**KAWARTHA PINE RIDGE DISTRICT SCHOOL BOARD
PUR24-087-ITT
Clarke High School Classroom Refresh**

ADDENDUM NO. 2

**BARRY BRYAN
ASSOCIATES**

Project No.: 24035
Date: May 9, 2024
Tender No.: PUR24087-ITT
Project: **RECONFIGURATION CLASSROOMS AT CLARKE HIGH SCHOOL**
Kawartha Pine Ridge District School Board

1
A208 PART SECOND FLOOR PLAN (200,201,202,203,204)
1:50

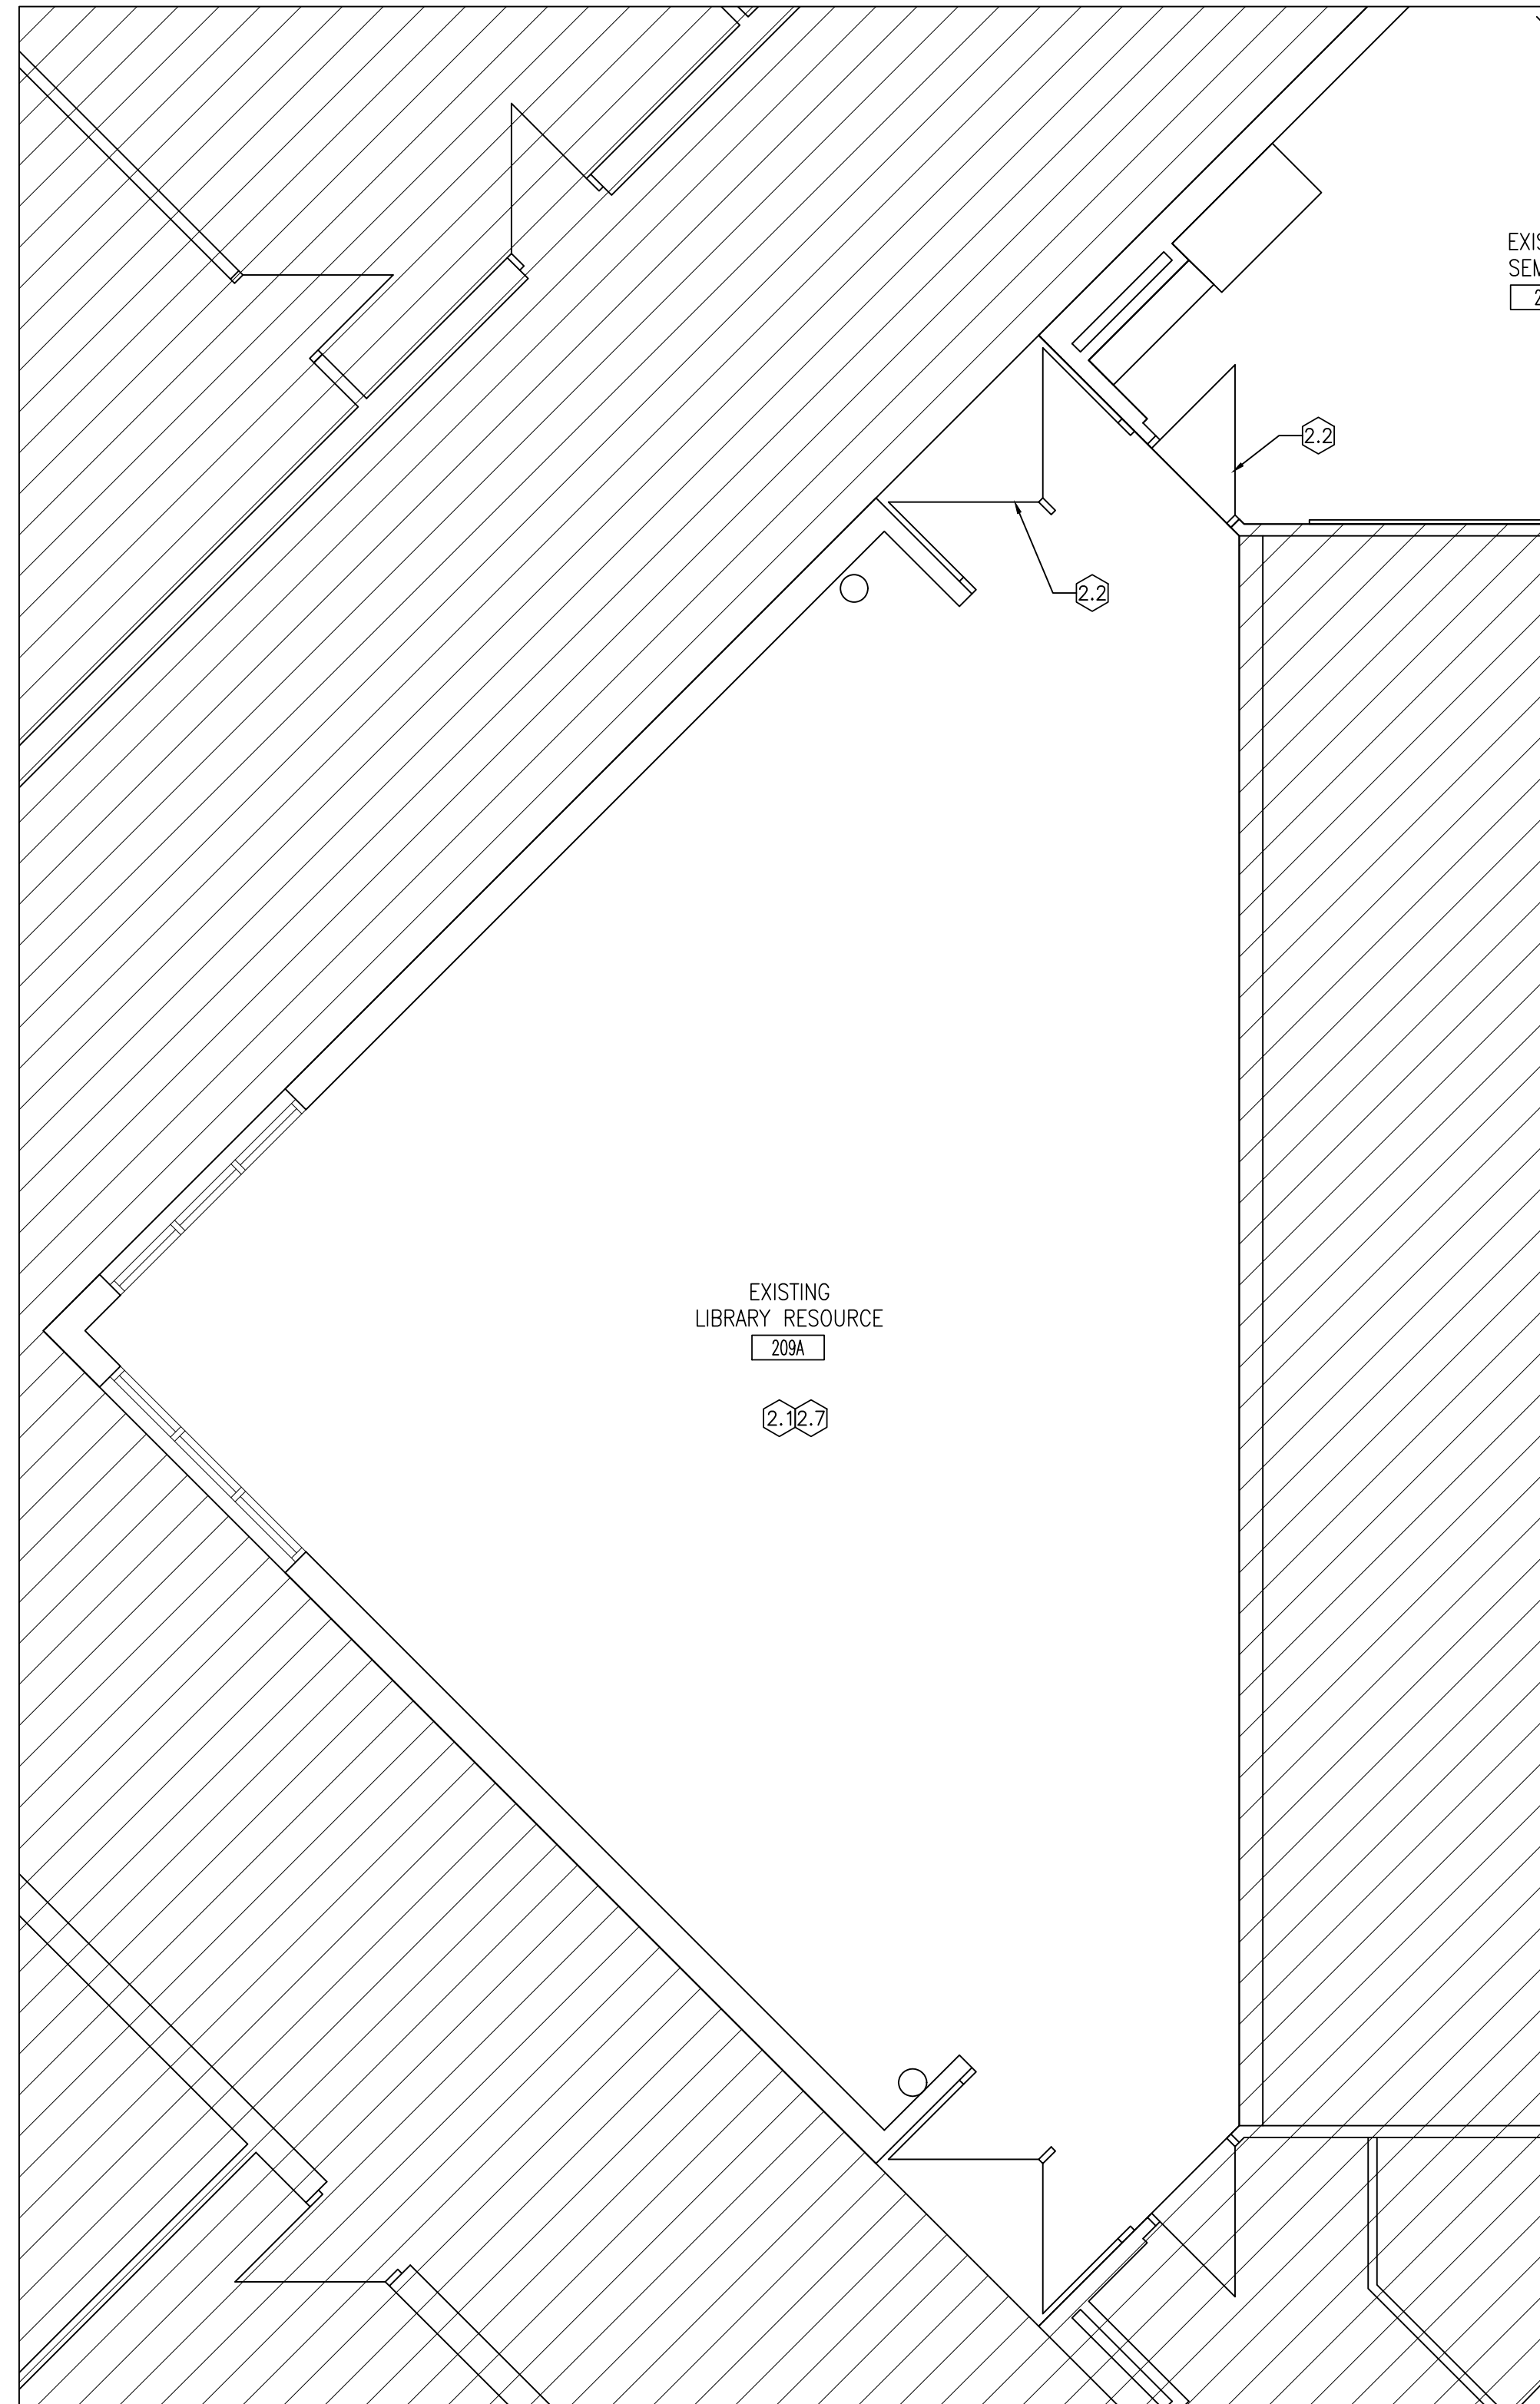
- .1 Addition of interior elevation tags.

1
A209 PART SECOND FLOOR PLAN (206,208)
1:50

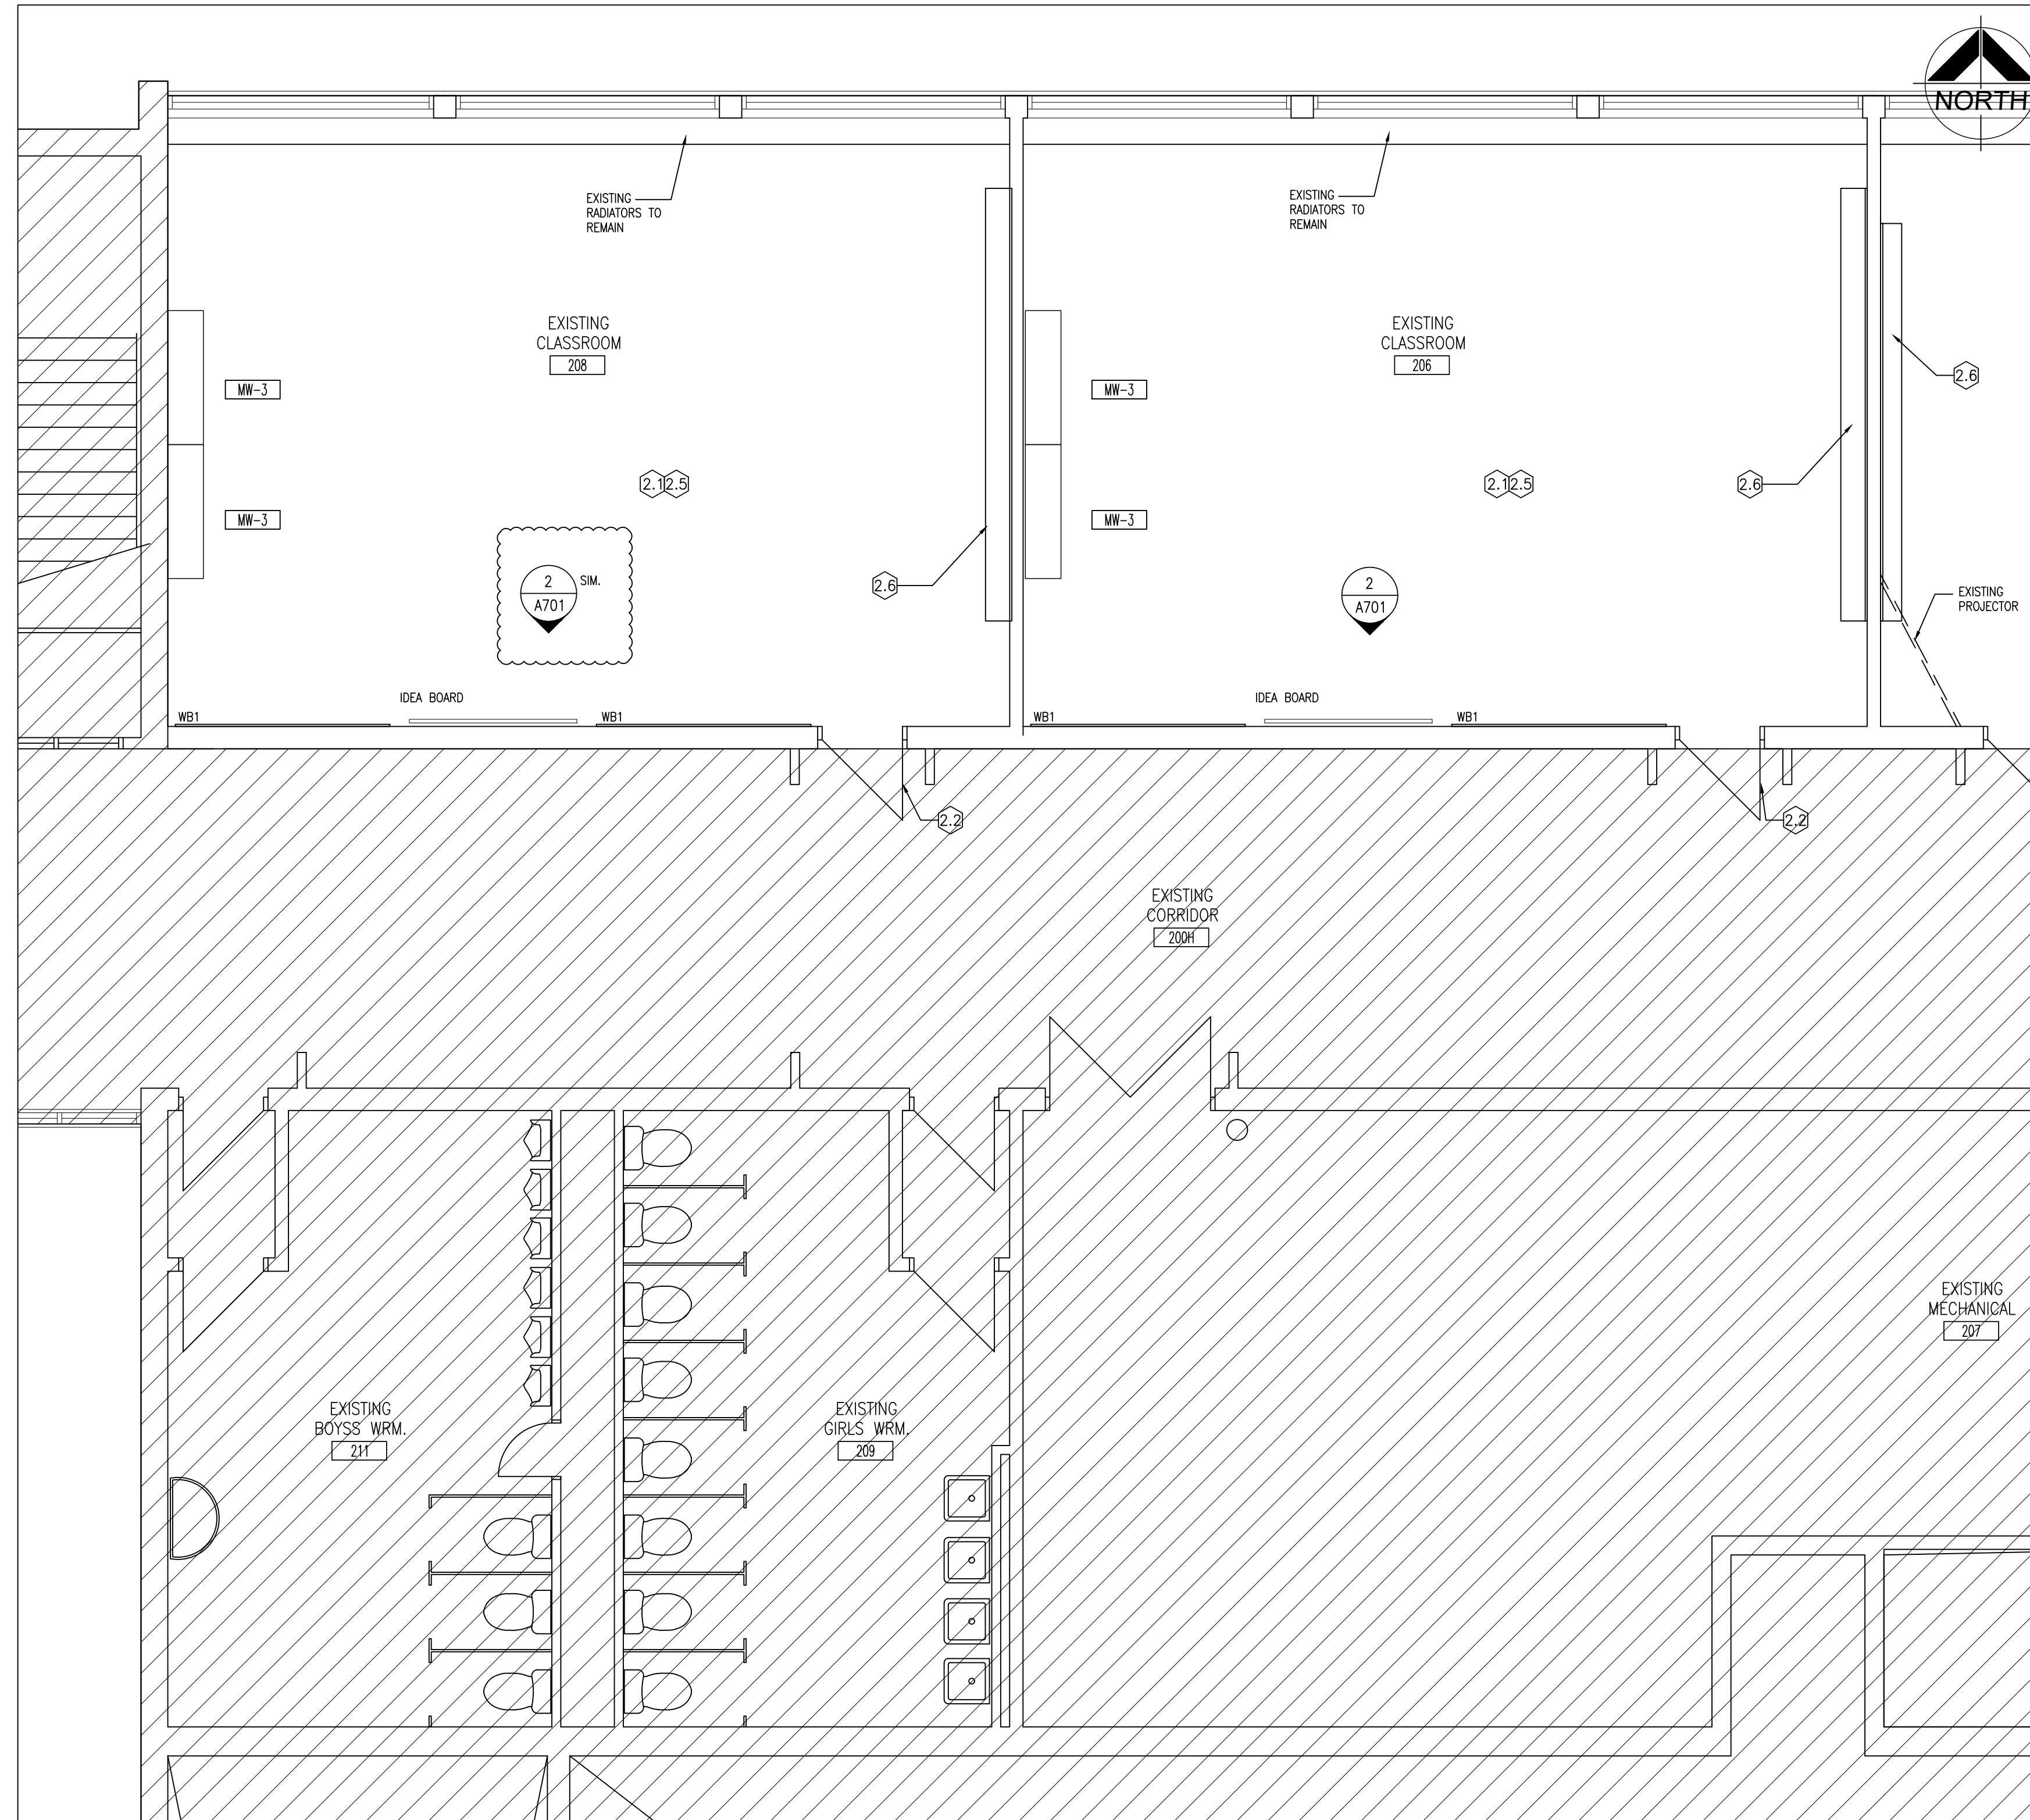
- .1 Addition of interior elevation tags.

1 PART SECOND FLOOR REFLECTED CEILING PLAN (200,201,202,203,204,205)
A212 1:50

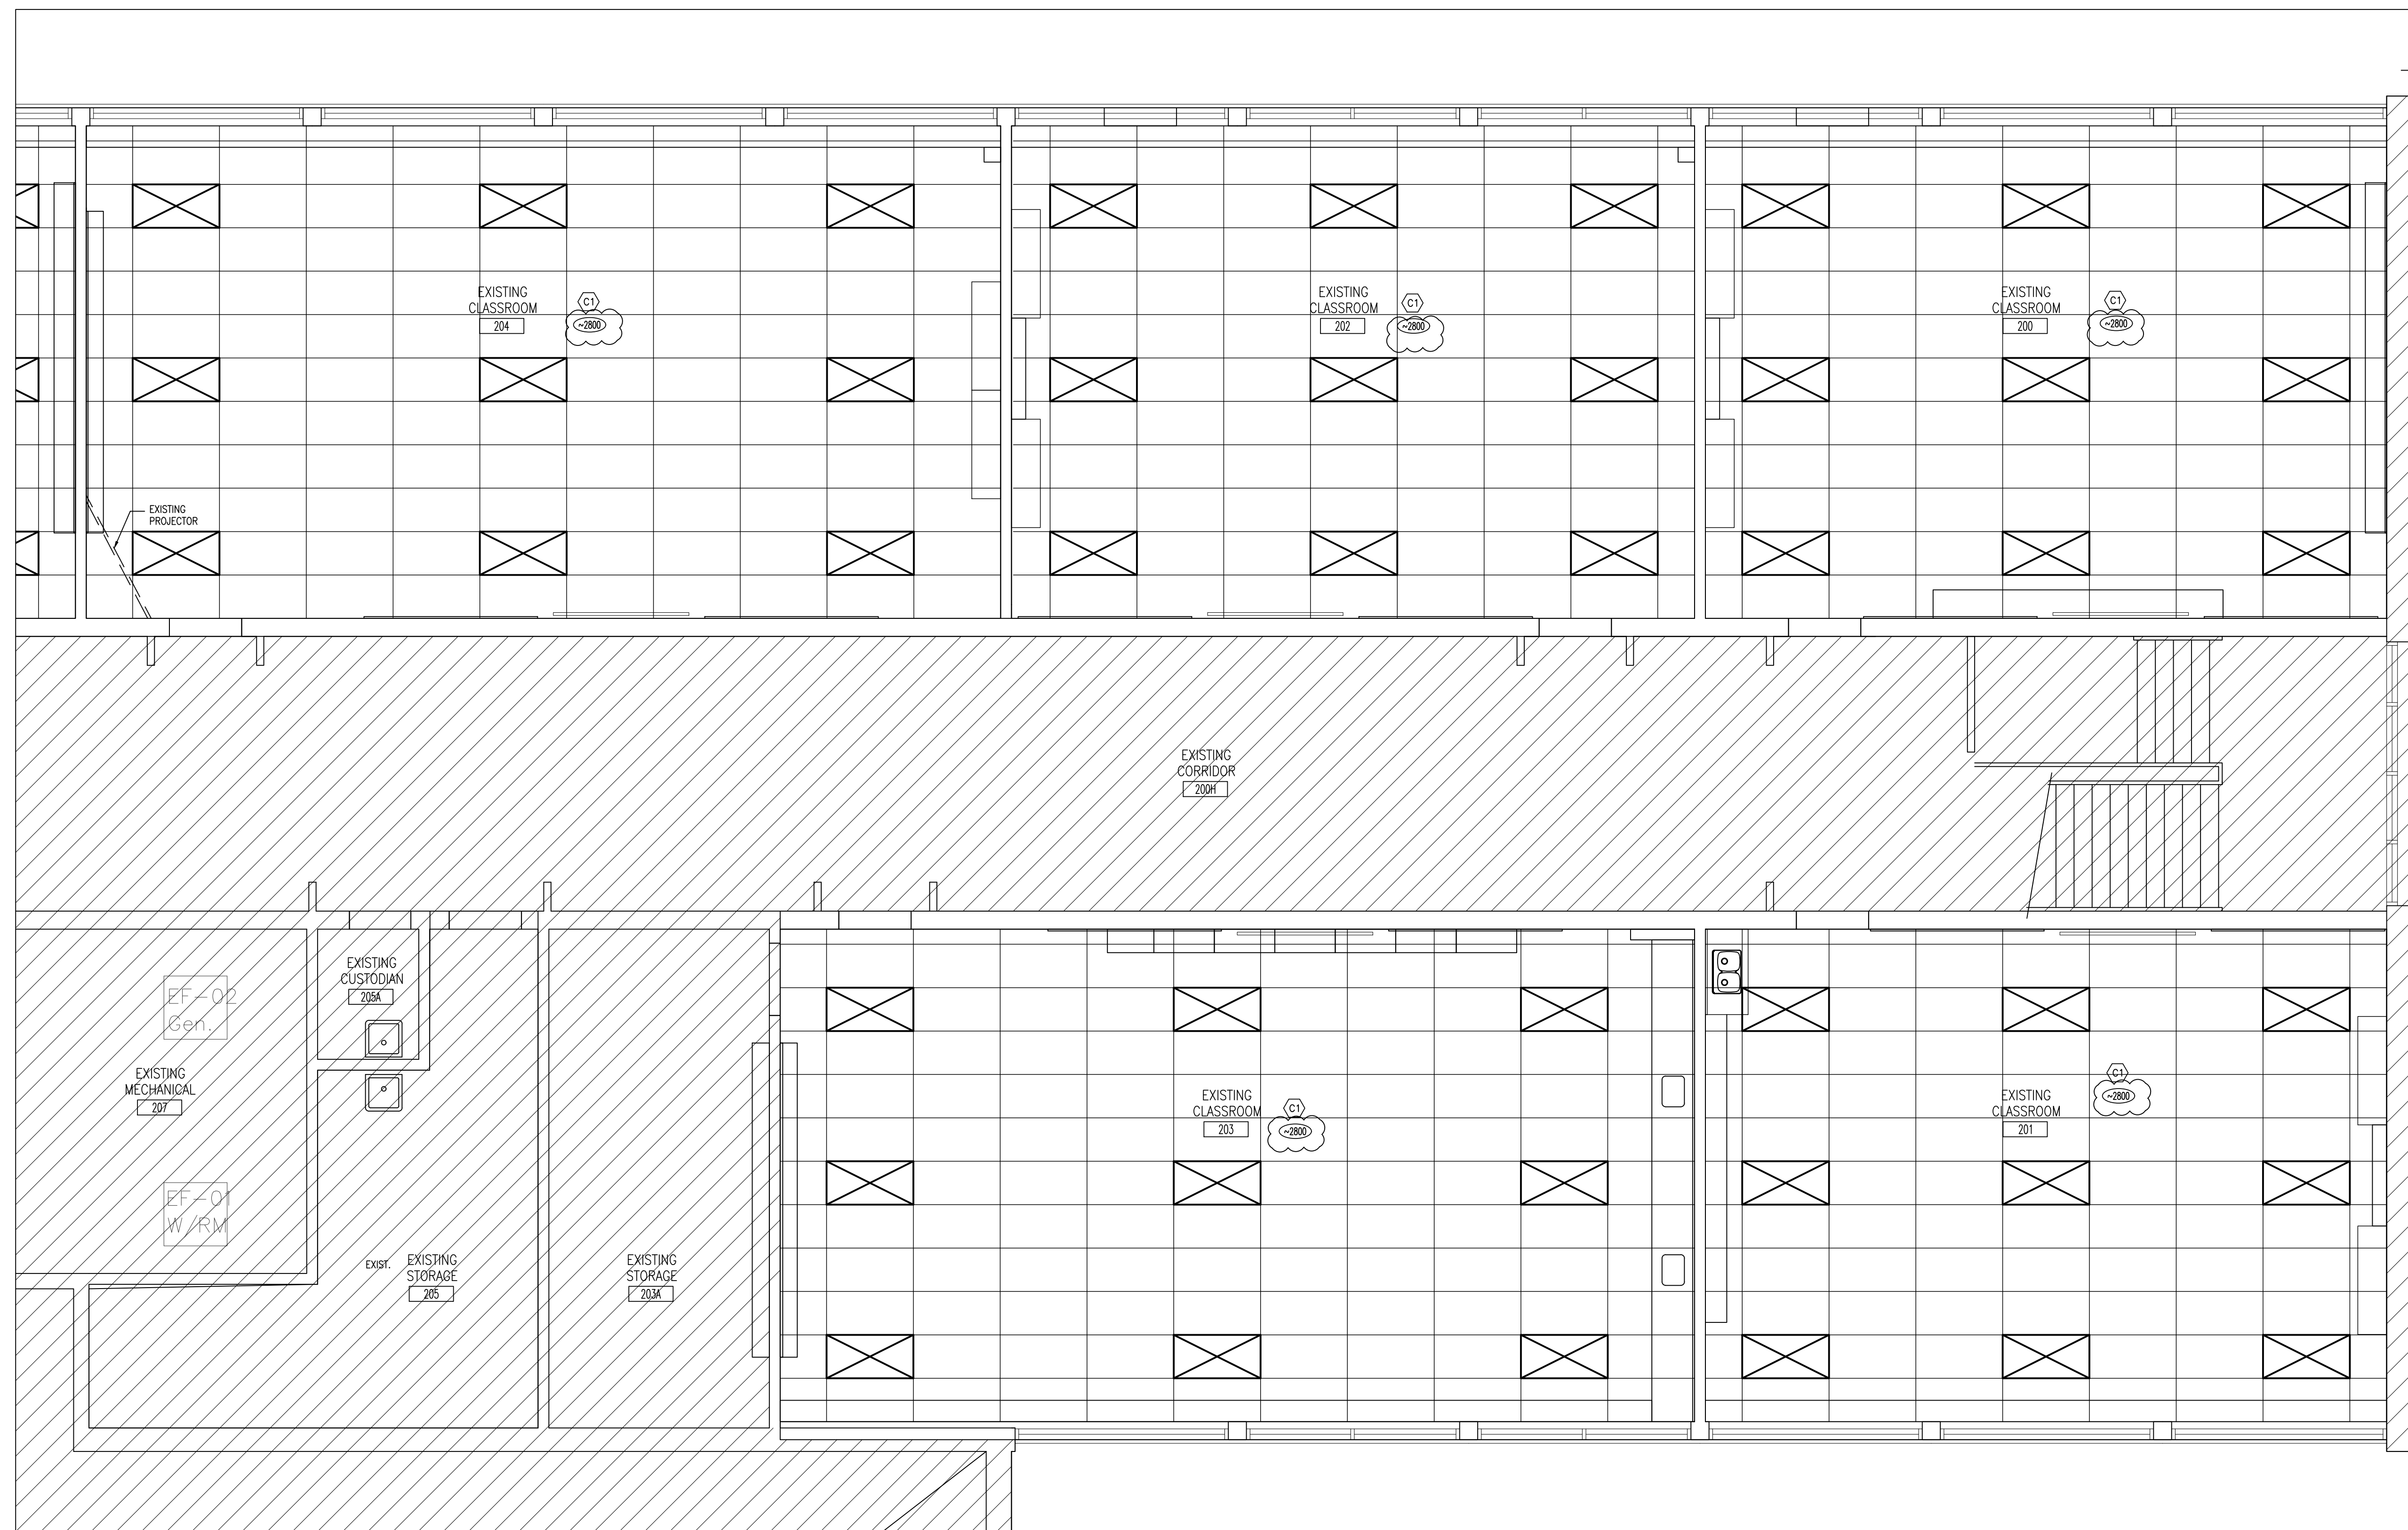
- .1 Revised "C1" ceiling type height and description.

1.9 **Question:** Abatement is removing 12x12 ceiling tiles. Are we leaving the existing assumed gypsum backing and framing with new t-bar below New ceiling C1 does not note any gypsum board in the assembly.

Answer: The abatement contractor is responsible for the removal of existing 12x12 tile and glue. The general contractor is to remove the existing drywall ceiling (if there is one). New ceiling "C1" suspended ceiling is a 1HR fire rated assembly.
